KOALA KOALITION
ECONETWORK PORT STEPHENS INC.

OBJECTION: CABBAGE TREE ROAD SAND QUARRY – MODIFICATION 3
State Significant Development Application SSD-6125-Mod 3

Proposed Mod3 expanded extraction areas and sections to be retired¹

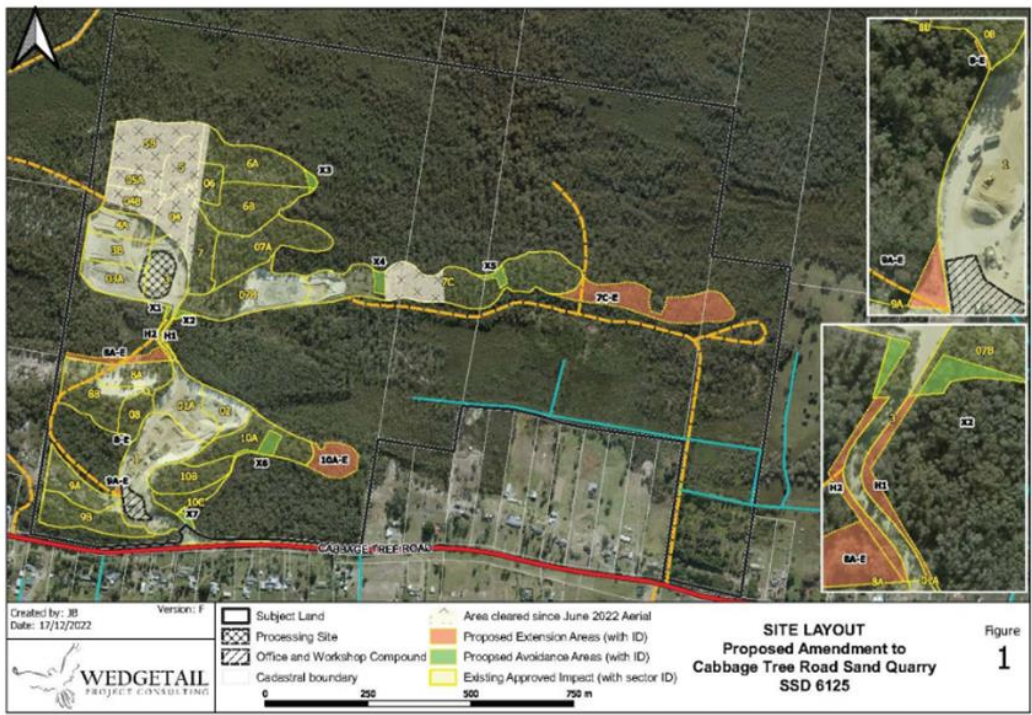
This map elucidates references made in this objection to the extension of the quarry.

- Mod 3 will encroach into a previously agreed and reserved wildlife corridor (Mod3 sections 8A-E and H1-2).
- Mod 3 section 7C-E extension to the east will further fragment the surrounding habitat.

- The increased clearing for the quarry expansion will break up high quality continuous habitat into smaller fragments, remove an additional 34 hollow bearing trees containing 41 hollows,² and increase edge effects across the site.

- Mod3 section (10A-E) was removed from the original footprint to reduce potential noise and dust impacts to residences near the southern-most extraction areas in response to EPA recommendations.³

- The mitigation now being proposed is insufficient: it would not be consistent with key objects of the *Environmental Planning and Assessment Act 1979* for an agreed on-site Biodiversity Stewardship site to be largely split in two and further fragmented, and for one of the key connections to other intact forest, the originally reserved wildlife corridor, to be narrowed to a pinch point.⁶

⁶ Refer map above. The area proposed to be cleared in the original reserved wildlife corridor (H1, H2 and 8A-E) is 0.44 ha larger than the area to be reserved (X1 and X2). Modification Report No. 3, sec. 4.2, Table 4-2, p 14
